Re: Drainage report for a portion of SU land bounded by Phoenix Ave.
and Georgine Drive, N.E.

H-221012 DECEMBER 26, 1979

AMENDED CHANGES "AS-BUILT" TO RUPLEY & ASSOCIATES
DOCUMENT DECEMBER 19, 1979, AND AS NOTED BY
FRED J. AGUIRRE (ASST. HYDROLOGY ENG.) MADE DEC.
24, 1979. DURING THIS MEETING WITH MR. AGUIRRE,
A REPRESENTATIVE OF CREST CONSTRUCTION (CONTRACTOR) & MYSELF,
IT WAS DETERMINED THAT ALL WOULD BE ACCEPTABLE IF
A BALANCE COULD BE SHOWN IN AREA "D" (PARTICULARLY LARGE
POND ON WEST). IF MR. AGUIRRE'S FIGURES ARE ASSUMED
CORRECT: THEN THE LARGE POND MUST CONTAIN

MEASURE DRAWING OF "MAJOR ROAD" AREA "D" (IN WEST AREA - A PORTION)
ALL GRADES & DIMENSIONS BY RIPLEY & ASSOCIATES

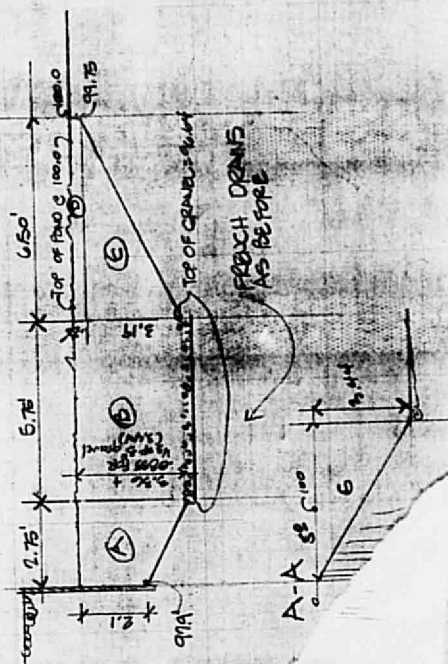
51.96
 - 48.00
 3909.387 CTRY REQ'D (3575) ∴ OK.
 FREACH DEANS TOTAL =

DRAINAGE AREA "D" SOUTH

AVAILABLE RUNOFF

AREA			PERVIOUS		
1	27	3360		}	$2\frac{1}{12} (.4) =$
2	22	180	"		
3	22	180	"		
4	22	180	"		
5	22	180	"		
6	22	670	"		
7	22	6000 17,990	IMPERVIOUS	$2\frac{1}{12} (1)$	<u>3598</u>
8	22	<u>150</u>			
		<u>12470</u>	23,510 ft ² (TOTAL AREA)		$\approx 4027 \text{ ft}^3$

RUNOFF TO POND

$$\begin{array}{r}
 4027 \text{ ft}^3 \\
 272 \\
 17 \\
 17 \\
 17 \\
 17 \\
 100 \\
 \hline
 12 \\
 3575 \text{ ft}^3
 \end{array}$$

AVAILABLE PONDING (PER YOUR CALCULATION SHEET)

$$3145.07 \text{ ft}^3$$

THEY DON'T BALANCE!

DeGuerri
12-24-79

3,575 CUBIC FEET. ATTACHED DOCUMENTATION,
VERIFIED IN FIELD BY ME AND ALL GRADE ELEV.
SHOT BY ME BEAR OUT THE FACT THAT

THE POND HAS AT LEAST A CAPACITY OF
3,909.38 CUBIC FEET WHICH IS IN EXCESS
OF THE 3,573 THERE FOR OK. POND ON

SOUTH WAS INCREASED WHILE AT SITE & WILL
POND A MIN. OF 280 FT³ & WILL USE 272 FT³
TO MAINTAIN COMPUTATIONS. NORTH "D" AREA

WILL POND 944 FT³ HOWEVER CITY FIGURE OF
775 FT³ SHALL BE ASSUMED THIS WILL
DEPOSIT 169 FT³ ADDITIONAL TO STREET —

REAR POND "C - SOUTH"

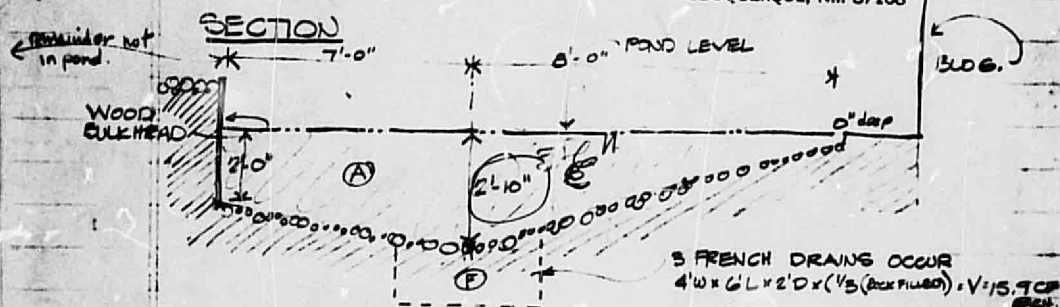
POND LENGTH = 105'-0"

$$A = 105 \times 7 \times \left(\frac{2.0 + 2.8333}{2} \right) = 1,776.2 \text{ C.F. } 1911 \text{ } 958$$

$$B = 105 \times 8 \times \left(\frac{2.8333}{2} \right) = 1,189.98 \text{ C.F. } 1344 \text{ } 1398$$

$$F = 3 \text{ EA FRENCH DRAINS } 3 \times 15.9 = 47.7 \text{ C.F. } 47.7$$

MIN. 3" GRAVEL COVER =

$$3 \text{ DRAINS } 4' \times 105 \times 15' = 131.19 \text{ C.F.}$$

$$\text{TOTAL POND CAPACITY} = 3,145.07 \text{ CF}$$
